Meeting Date: Tuesday 4 June 2013
Location: Committee Room 2, Level 5, Civic Centre, 1 Devlin Street, Ryde
Time: 5.00pm

NOTICE OF BUSINESS

Item	Page
1 CONFIRMATION OF MINUTES - Meeting held on 21 May 2013	1
2 29 VIMIERA ROAD, EASTWOOD - LOT 10 DP 4574. Building Certificate Application for unauthorised building works to the existing dwelling, including a first floor addition, extensions to the rear of the dwelling and demolition. BC2013/0003. <i>INTERVIEW 5.00PM</i>	5
3 52A PELLISIER ROAD, PUTNEY. LOT 2 DP 859984. Development Application for alterations and first floor additions to the existing dwelling, and new swimming pool. LDA2013/0012. <i>INTERVIEW</i>	25
4 52 DARVALL ROAD, EASTWOOD. LOT 10 DP 13514. Local Development Application for the use of existing building as a secondary dwelling and an outbuilding. LDA2013/0100. <i>INTERVIEW</i>	97
5 3-5 TRELAWNEY STREET, EASTWOOD. Part LOT B & LOT A DP 401296. New mixed use development: a building with six retail/commercial tenancies (534m ²); 57 apartments (13X1 bedrooms, 44X2 bedrooms) and basement parking, and strata subdivision. LDA2011/0611. <i>INTERVIEW</i>	146

Figure 3 – Shadow diagram of 29 Vimiera Road, Eastwood

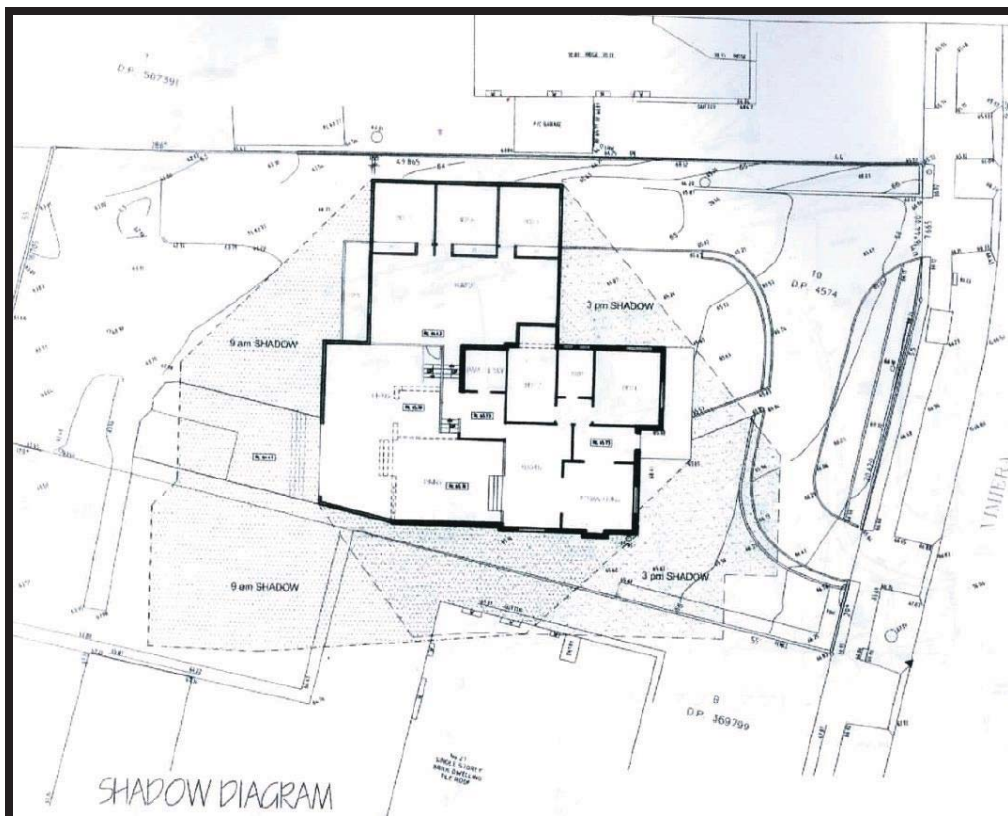
Comment: As demonstrated in the shadow diagrams submitted as part of the development application (see below) the proposed development will see some minor additional overshadowing to the neighbouring allotment at No.27 Vimiera Road as a result of the additions to the western elevation of the dwelling. Although creating a minor increase in overshadowing, it is considered the north facing windows would have previously been overshadowed by the existing dwelling on site due to its position and pitch of roof. Accordingly, the overshadowing to the neighbouring allotment at No.27 Vimiera Road is considered to be acceptable.

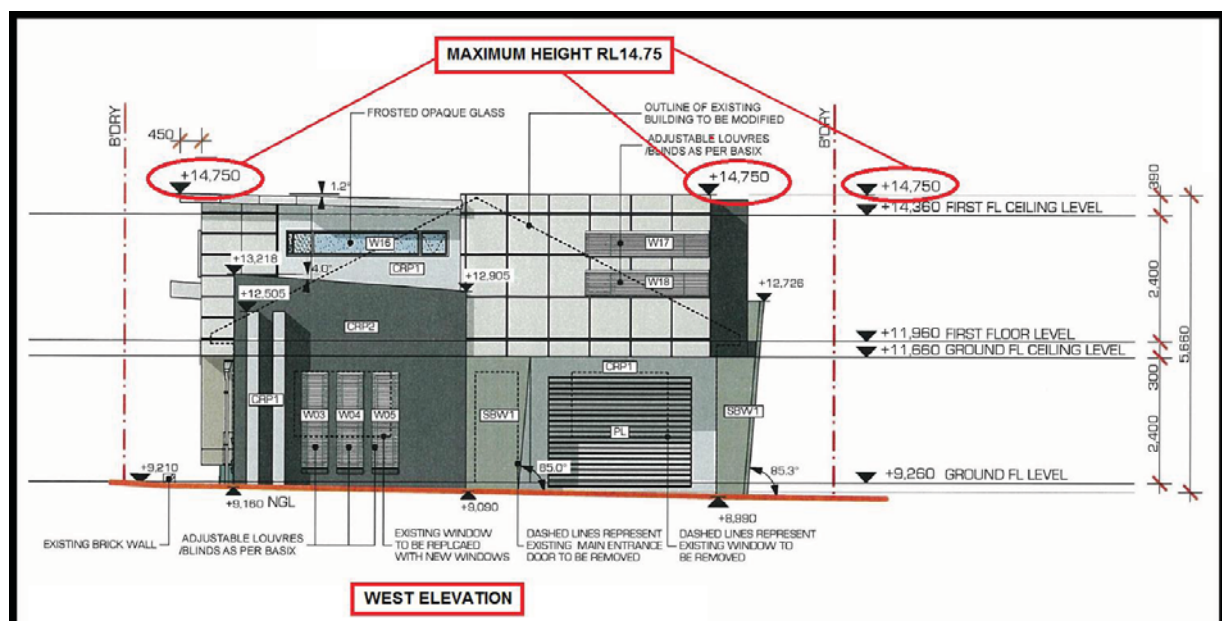
B. Building Height – *concerns are raised over height of the proposed building and that it breaches the caveat restricting the height of any development on the site.*

Given the plans submitted with the development application demonstrate the proposed building height does not exceed reduced level 14.75 Australian Height Datum, and the general prescribed building height for development within the R2 zoning of the site, neighbouring objections on the grounds of excessive building height is not supported. This is illustrated in the following drawing (proposed west elevation).

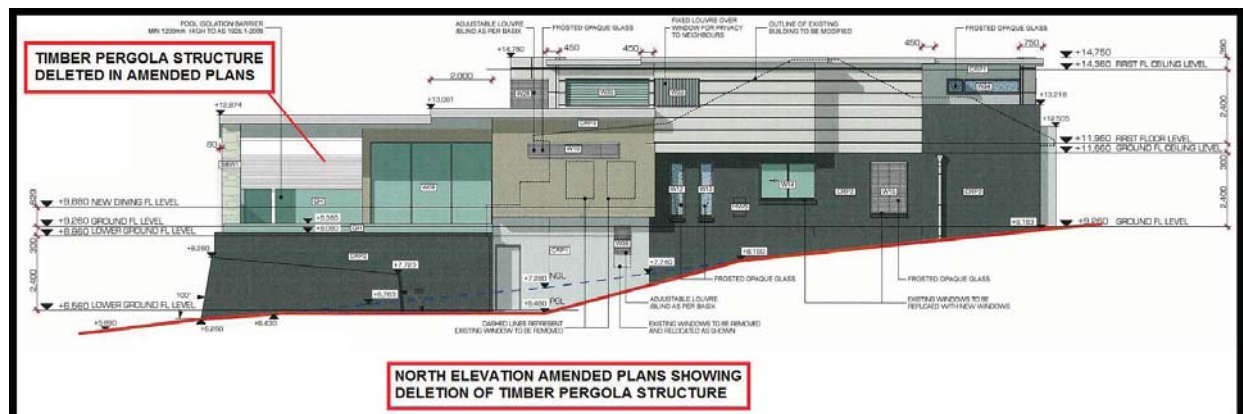
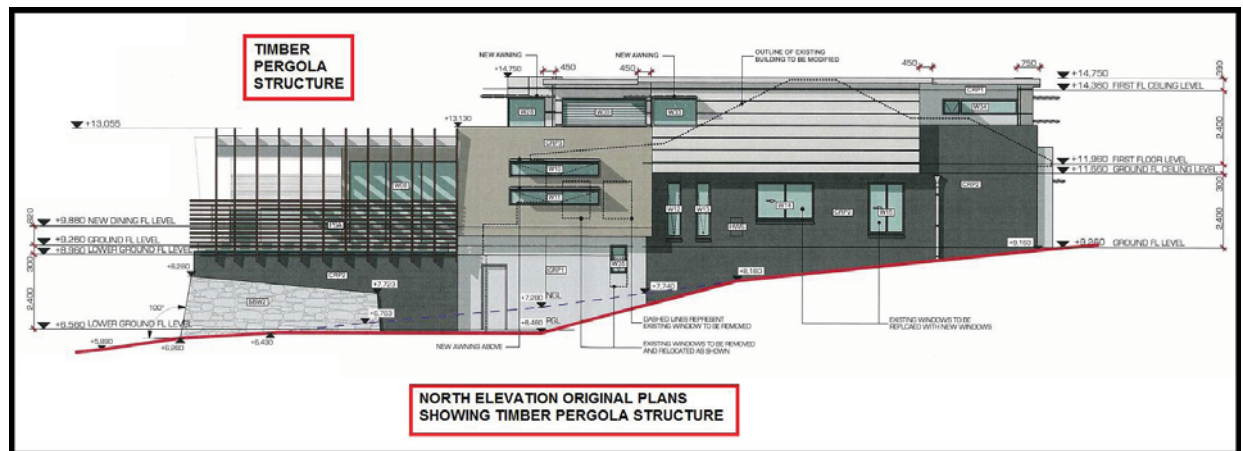
The following are the original plans and the amended plans (north elevation) showing the deletion of the timber pergola structure.

On 12 April 2013 amended plans were submitted to council that removed the significant timber pergola structure over the swimming pool which added to the bulk and scale of the dwelling. Additionally, minor amendments were made to reduce the width of the dwelling including modifications to the first floor. Overall these amendments are considered to have reduced the overall bulk and scale of the dwelling over that which was originally proposed.

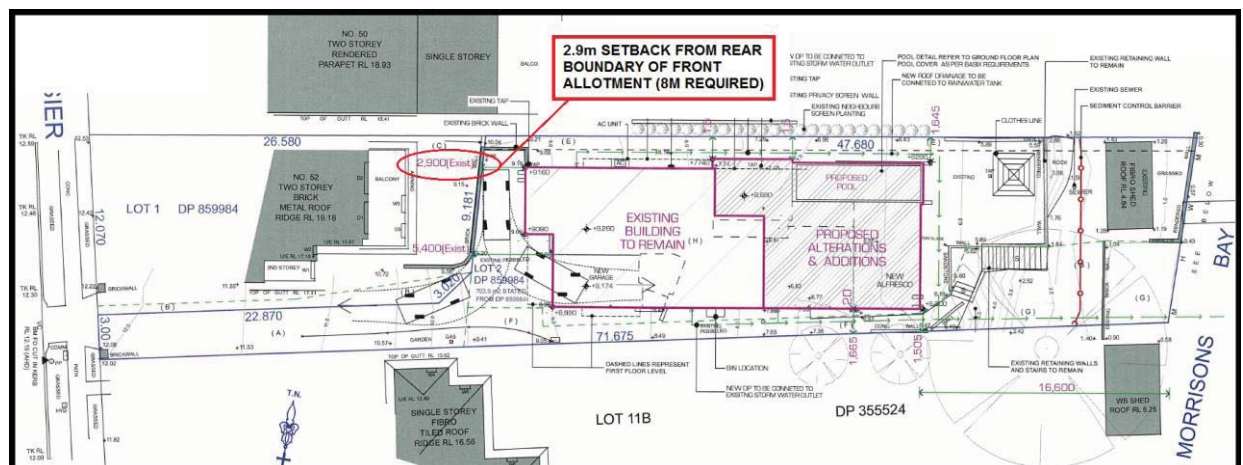
The following drawing shows the setback from the rear boundary of the front allotment.

Section 2.8.3 of Part 3.3 of the Ryde DCP 2010 prescribes development controls for the rear setbacks. Specifically, that dwellings on a battle-axe (hatchet shaped) allotments are to be setback from the rear boundary of the front allotment a minimum of 8m. As demonstrated within the attached Compliance Checklist, the proposed development will result in a dwelling house with a rear setback of minimum 2.9m and maximum 5.4m (see drawing in the Submissions section of report (objection E)).

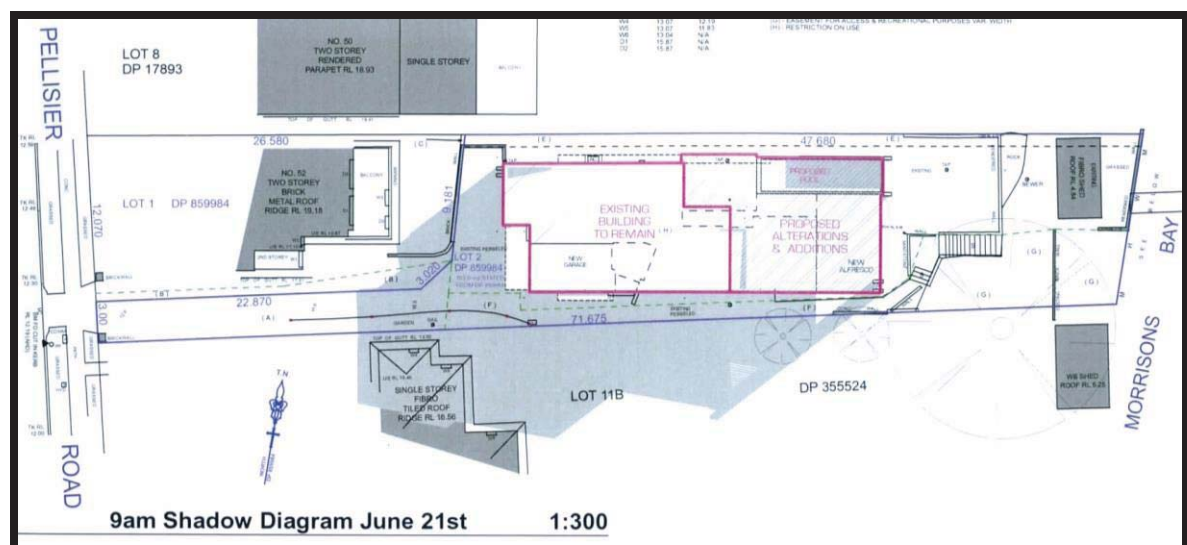
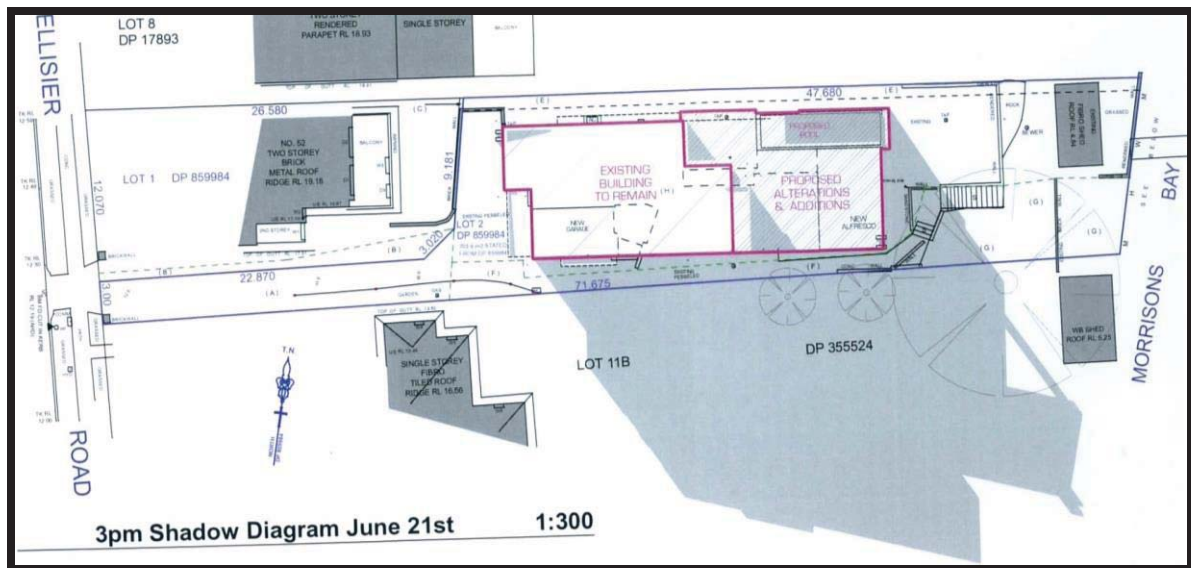
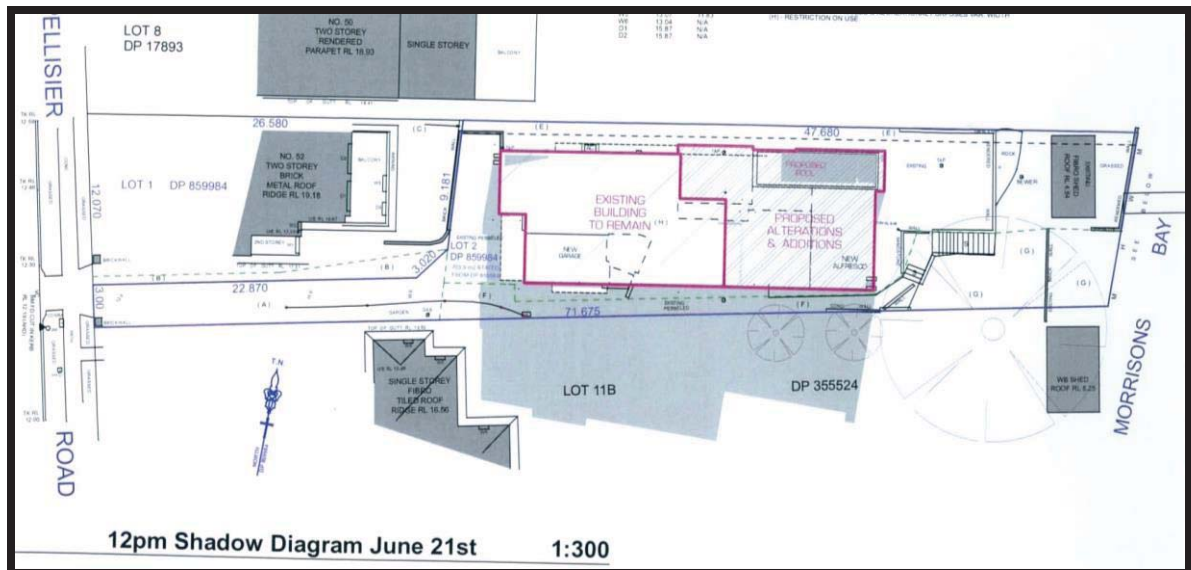
As demonstrated in the shadow diagrams submitted as part of the development application (refer to extracts below), the proposed development is shown to have minimal overshadowing impacts on the neighbouring dwellings. It is acknowledged that there will be some increased overshadowing to the private open space of 50 Pellisier Road however this is primarily due to the orientation of the allotments. It is noted that 50 Pellisier Road will still receive the minimum required amount of sunlight to its private open space (ie sunlight to at least 50% of the principal area of ground level private open space is not reduced to less than 2 hours between 9am and 3pm on June 21) as stipulated by the Ryde Development Control Plan 2010.

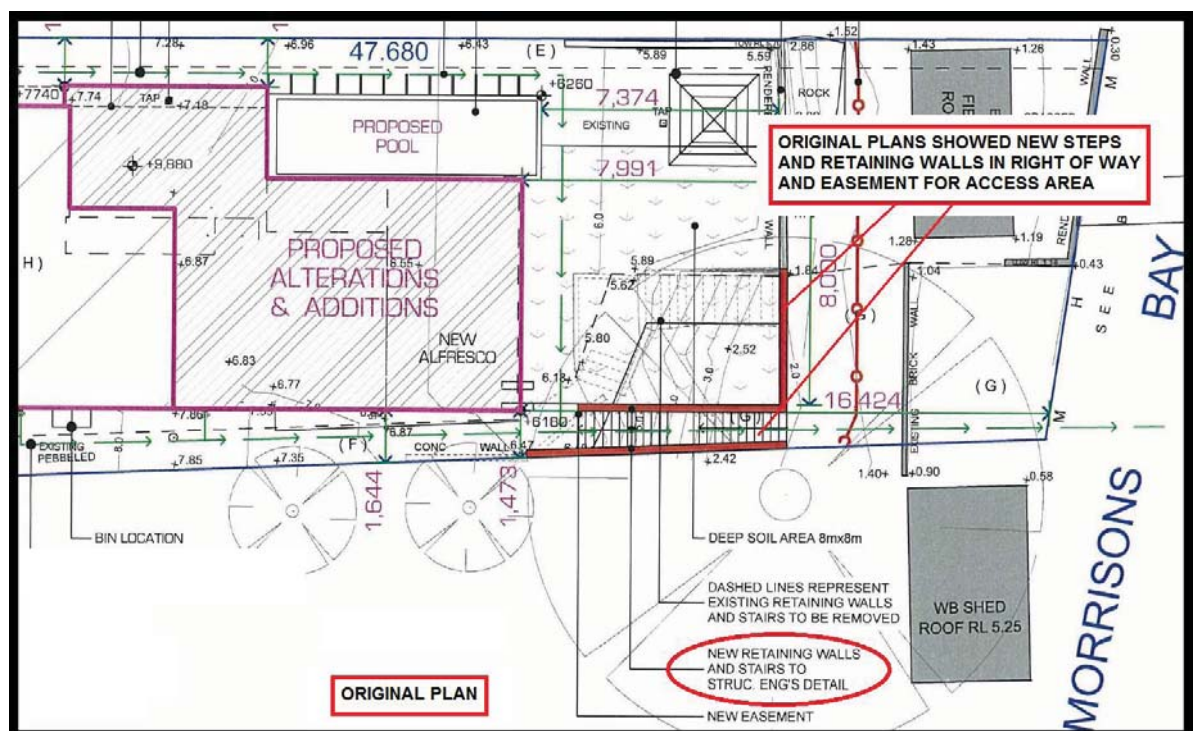
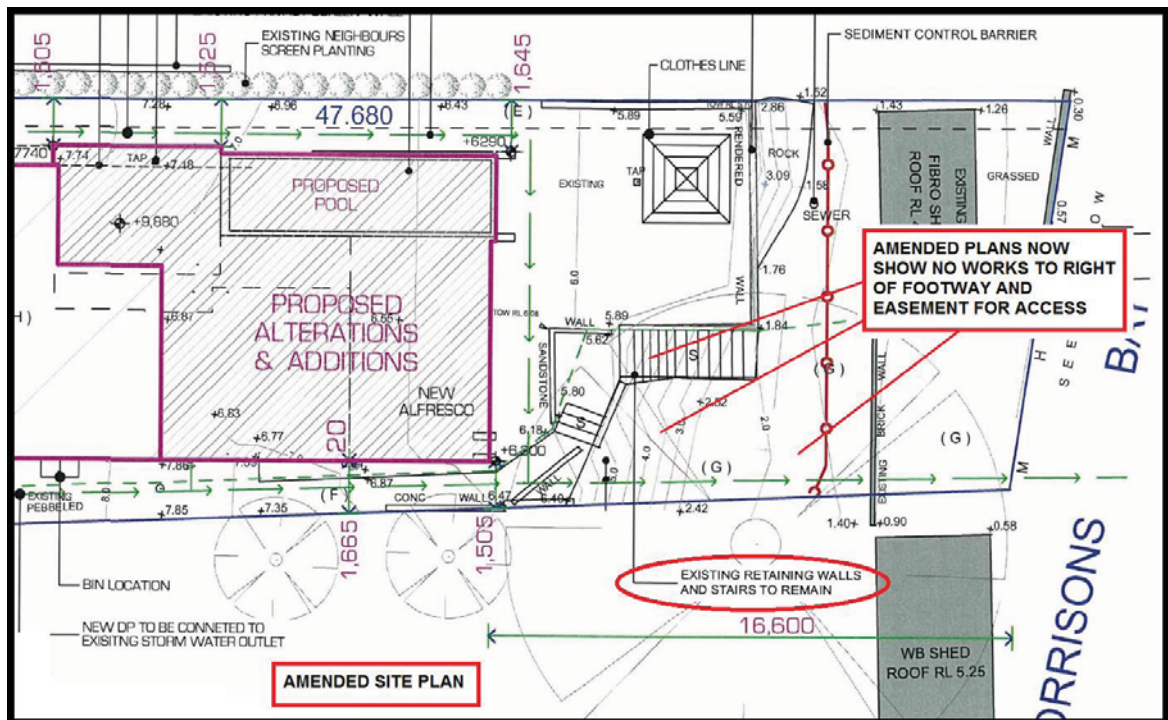
H. Easements/Right of ways – concerns are raised over the development proposing works to be undertaken within easements and right of ways. In particular, the adjoining property to the west (Lot 1, No 52 Pellisier Road) benefits from a “right of footway” and an “easement for access and recreational purposes” over the subject land – and concern is raised that the development impacts on these easements.

The following drawings show the location of the relevant right-of way and easements, and the amendments to the plans to address the issue.

On 12 April 2013 amended plans were submitted to Council that removed all proposed works to be undertaken within the easements and right of ways to avoid any encroachments.

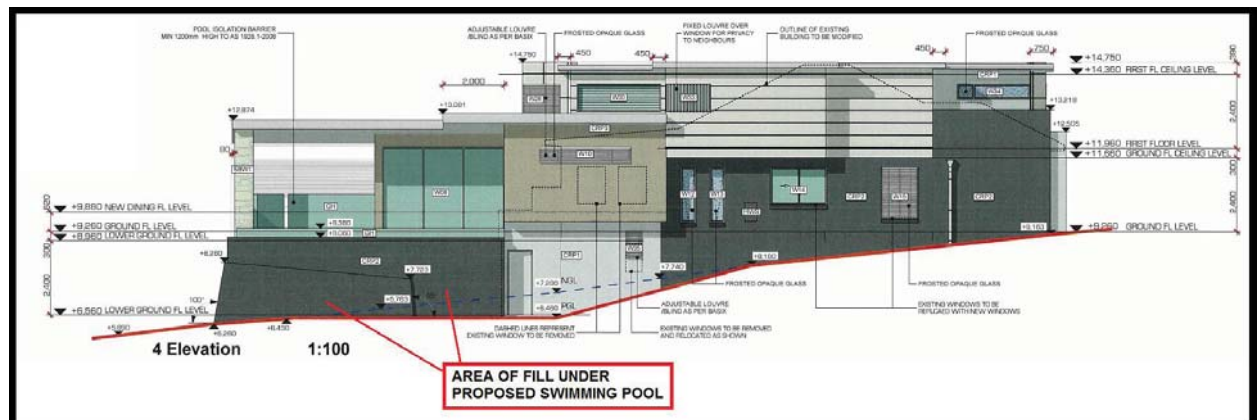
The following drawing (north elevation) shows the area of fill under the proposed swimming pool.

Figure 5 – West Elevation indicates privacy screen

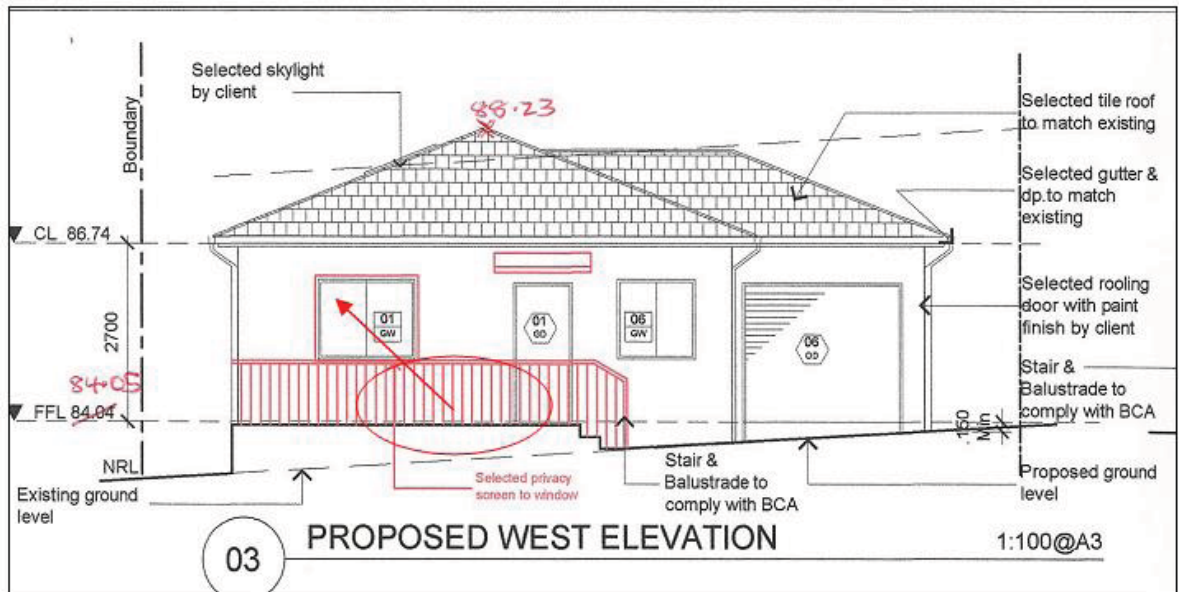
Figure 4 –
The view looking towards 50 Darvall Road, from the bedroom on the western elevation. A privacy screen and screen planting 2.7m high are proposed.

NORTH ELEVATION

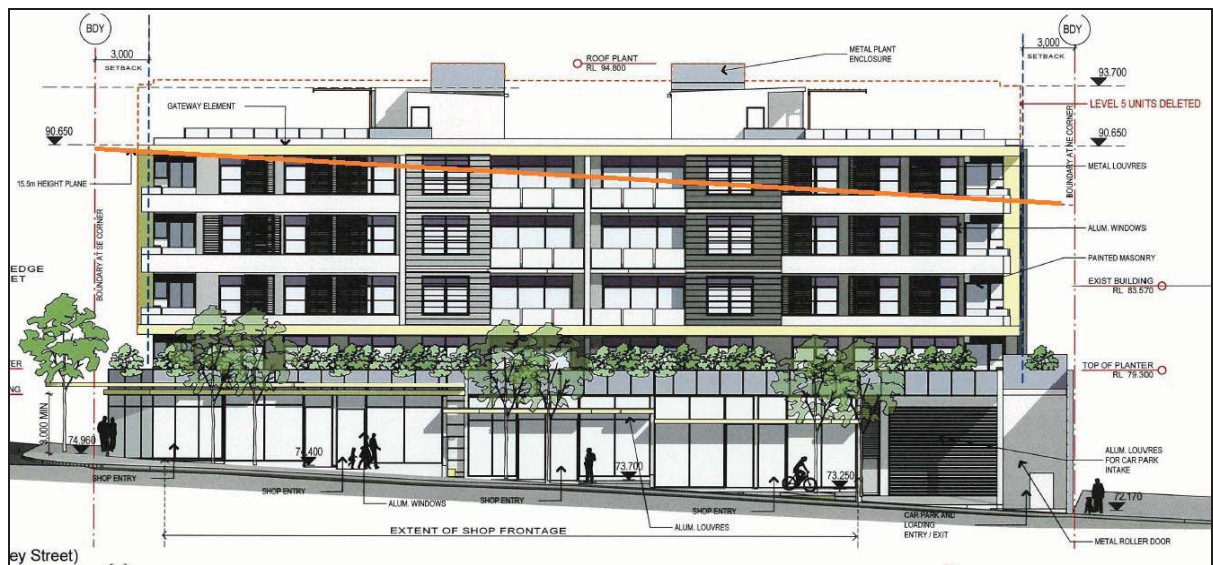
Below is the amended north elevation which shows the units deleted (dotted outline). The plan also shows the height limit of 15.5m demarcated by the bold orange line.
